April 13, 1973

SUBJECT: Information Letter
Illinois Low Power Reactor Assembly (LOPRA)
License R-117

This letter describes two changes that are planned for the LOPRA. These involve changes in the region that surrounds the basic core from those that were described in the Safety Analysis Report (SAR). The changes do not require Commission authorization as specified in 10 CFR 50.59.

Sketch of Top View of the LOPEA Core Showing the Location of the Safety Control Rods in the LOPEA Core Lattice

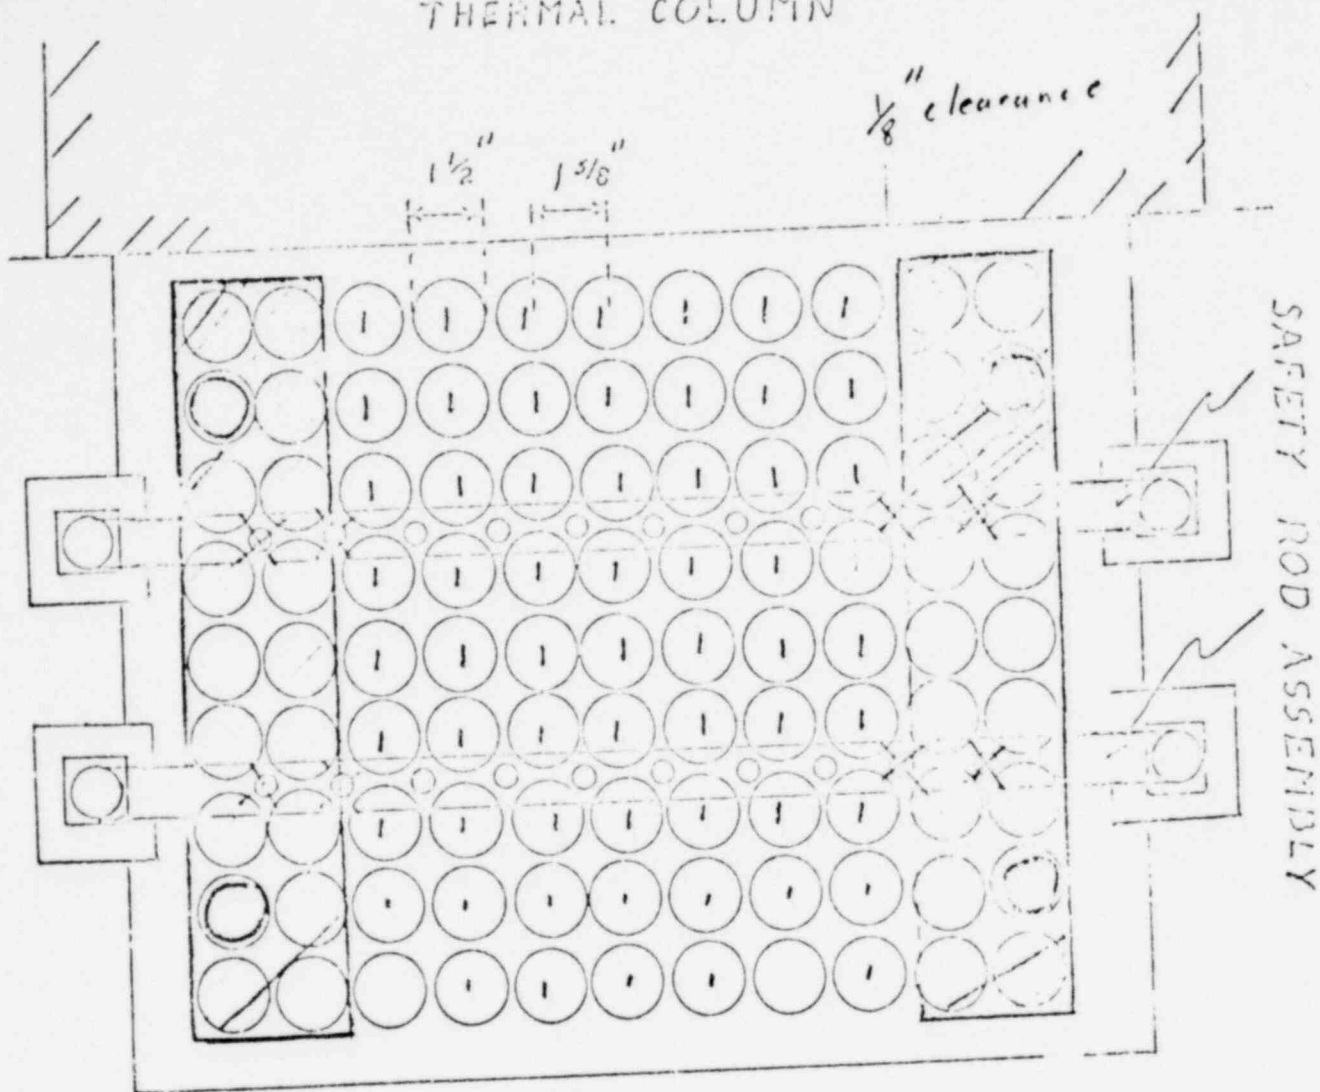
To indicate the changes, reference is made to Figure 16, page 29 of S.A.R., February, 1970 and the figure enclosed with this letter. At the present time, criticality is obtained with 61 fuel elements using a basic 7 x 9 array. The 7 dimension is parallel to the thermal column as shown by the figures. The succeeding parallel rows contain 7 elements with the exception of the last row which contains only 5 elements.

The plans call for placing graphite reflectors on the two sides of the array which presently do not contain fuel elements. The reflector will have dimensions of 3 x 14 1/2 x 16 inches, which corresponds to the space on the grid plate and the lateral and height dimensions of the fuel array. Pins, which fit into the grid plate openings, will be placed on the bottom portion to keep the assemblies rigidly in place. To make room for the reflectors, the four outer (two on each side) poison tubes will be removed from both of the present safety rods.

With this change, it is estimated that a critical assembly may be obtained with 57-58 fuel elements. Graphite dummy elements may be placed in the outer (9th) row for either gaining or adjusting the excess reactivity of the core.

Removal of the outer pins of the safety control rods will result in a slight decrease in the negative reactivity. It can be noted from the figures that the pins to be removed are outside the core region. The present worth

- Location of 61 fuel elements with present core.
- ✕ Safety control rod pins to be removed.
- ⊗ Location of pins to give assembly rigidity.
- ▨ Shaded areas are locations of new graphite reflector assemblies.
